Office Action Summary

09/864,389

PINCHASIK ET AL

DETAILED ACTION

Fig. 30

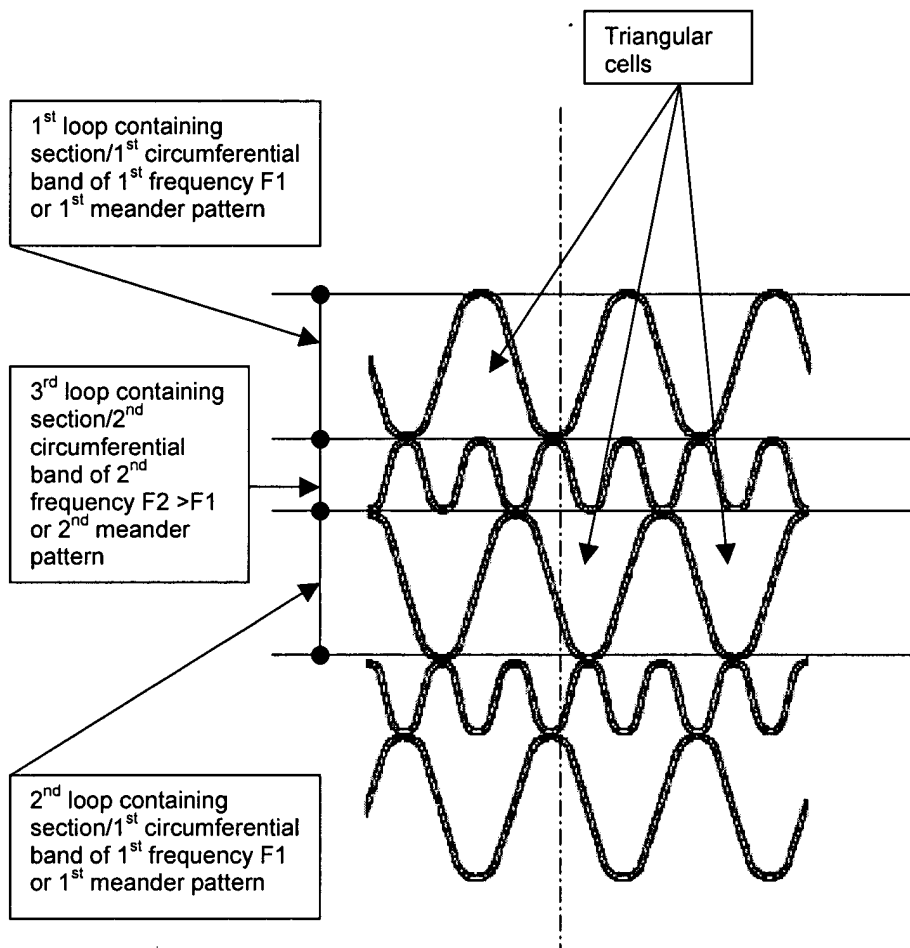
As to claims 1-2, 4, 6-7, 11-12, 14, 16-17, 19, 42-47, JAYARAMAN (see Fig. 30 on page 3 above) shows a stent structure comprising 1st and 2nd loop containing sections/1st circumferential bands/1st meander pattern of a 1st frequency F1, 3rd loop containing sections/2nd circumferential bands/2nd meander pattern of 2nd frequency F2 > F1 to define cells/triangular cells as recited in the claims.

a. 3rd loop containing sections are configured in a sinusoidal shape of a frequency F2 higher than a frequency F1 of 1st and 2nd loop containing sections (Fig. 30, page 3 above), therefore 3rd loop containing sections do expand or contract when the stent structure is bent/expanded, thus 3rd loop containing sections do contribute to the cells elongating or shortening when the stent is in a curved configuration/expanded configuration. In addition, because the 3rd loop containing sections have more stored length (or more springy/wavy than 1st and 2nd loop containing sections), the 3rd loop containing sections are more flexible and more sensitive to deformation than 1st and 2nd loop containing sections, therefore during flexing of the stent, 3rd loop containing sections contribute more to the stent deformation than 1st and 2nd loop containing sections.

Alternatively, it would have been obvious to one of ordinary skill in the art to size/configure the 3rd loop containing sections so as to make the 3rd loop containing sections more flexible than the 1st and 2nd loop containing sections as this modification of size and shape to make a stent having sections more flexible (for increasing overall flexibility of the stent) than other more rigid sections (for radial strength to keep the lumen of the vessel to open) is well known in the art.

b. Cells/triangular cells in one side of a neutral axis of bending of the JAYARAMAN stent will be in a tension condition and in the other side of the neutral axis will be in a compression condition. Cells under the tension condition

will open in length and narrow circumferentially and cells under the compression condition will shorten in length but widen circumferentially.

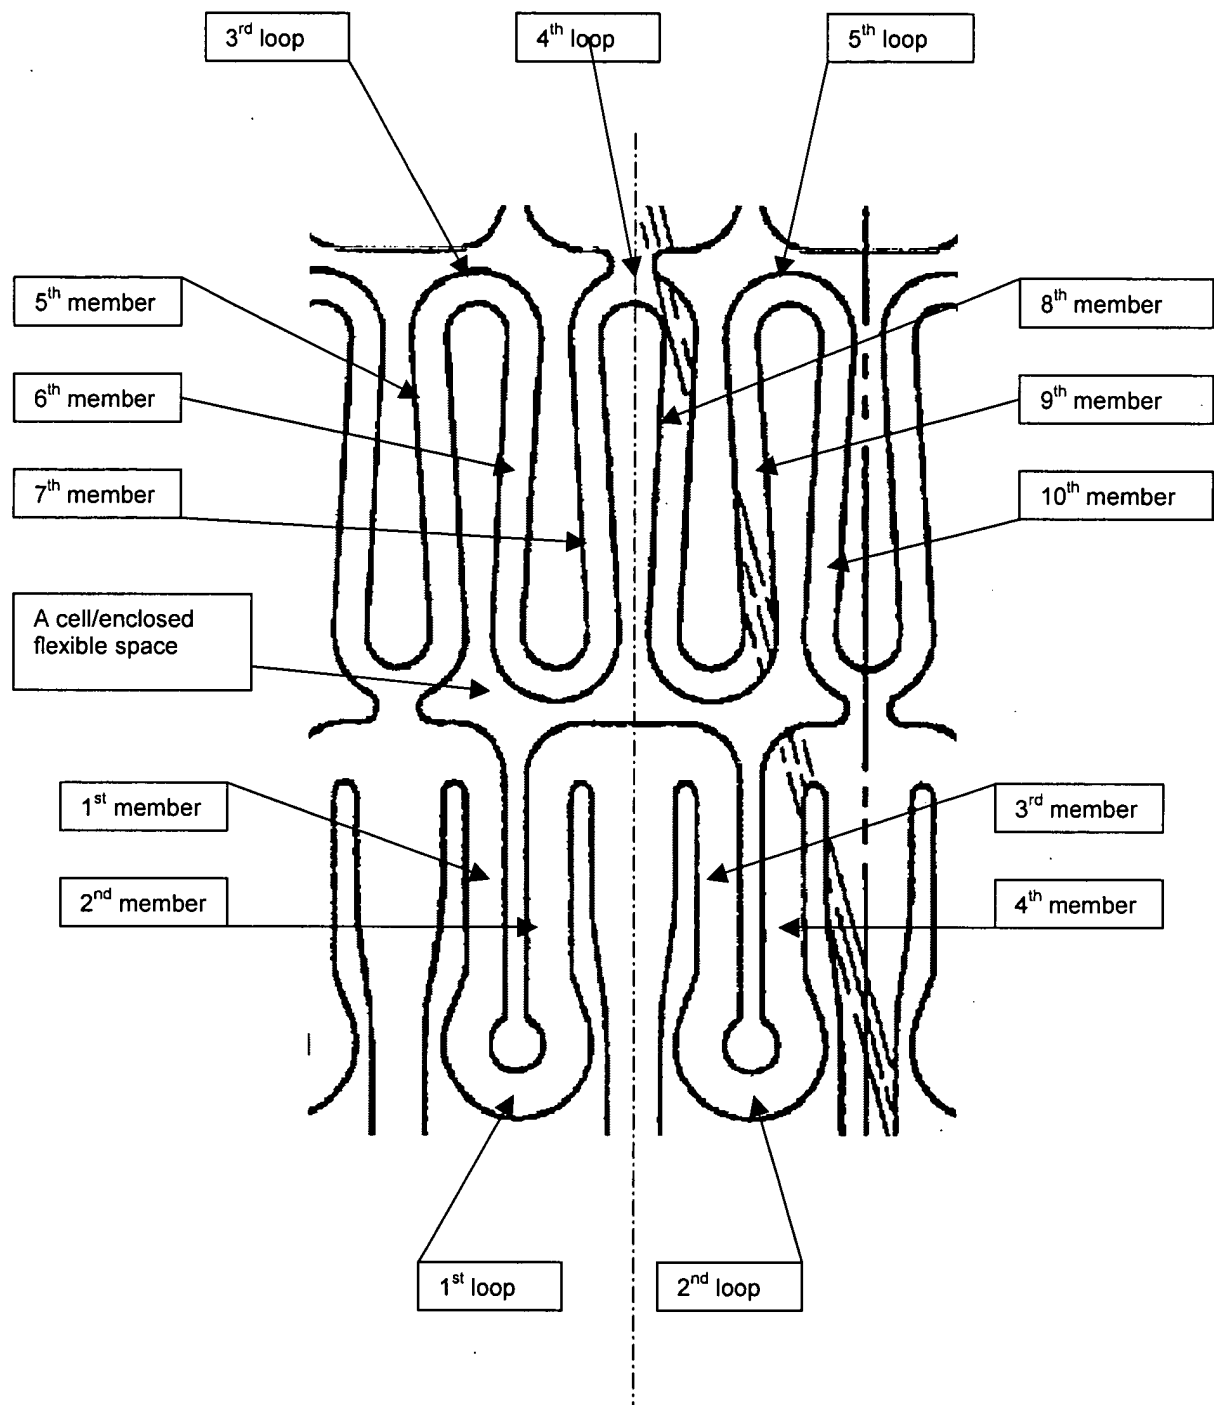
As to claims 21-22, 24, 48-49, BROWN (Fig. 2, page 5, this paper) shows even 1st meander patterns substantially are 180 degree out of phase with odd 1st meander patterns. Even 1st and odd 1st meander patterns alternate with and are spaced from each other to form a uniform flexible structure as recited in the claims. When expanded in a curved vessel, BROWN shows cells that increase in length in one side of a neutral axis/bending axis and cells that decrease in length in another side of the neutral axis.

A cell in Fig. 5, BERRY et al.

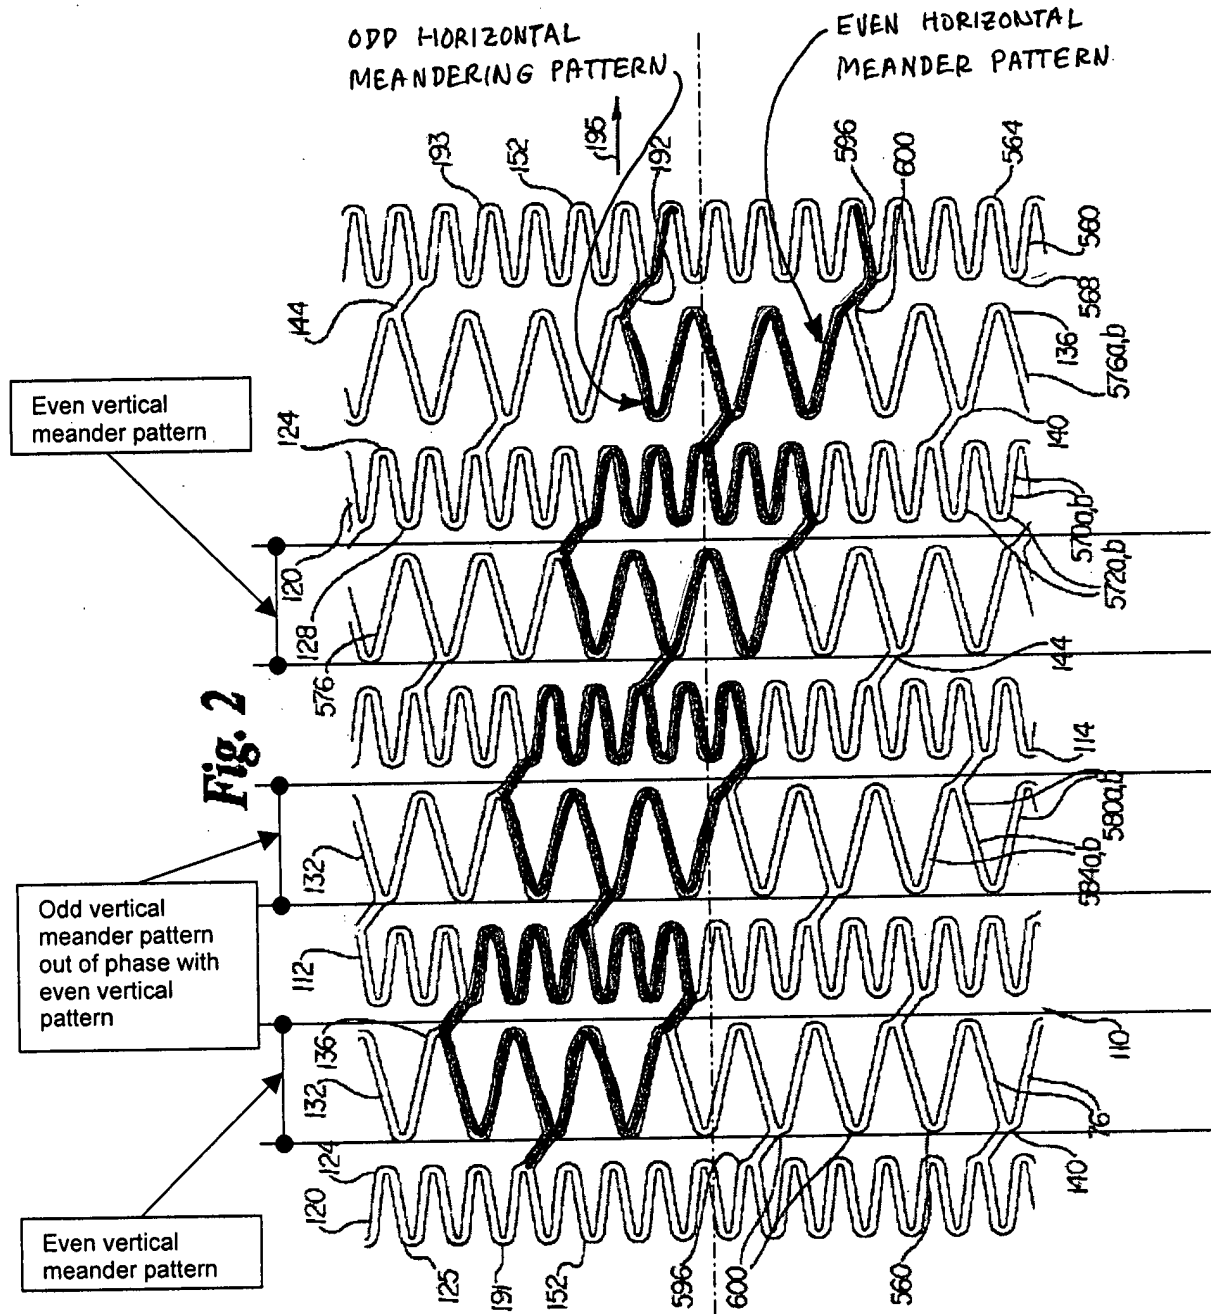
As to claim 26, BERRY (see BERRY Fig. 5 and BERRY triangular cell in page 4, this paper). Notice that BERRY stent comprises many flexible triangular cells to form a uniform mesh of flexible cells. Each BERRY triangular cell has a central axis BB. When expanded in a curved vessel, BERRY triangular cell will increase in length in one side of the neutral axis and decrease in length in one side of the neutral axis as recited in the claim.
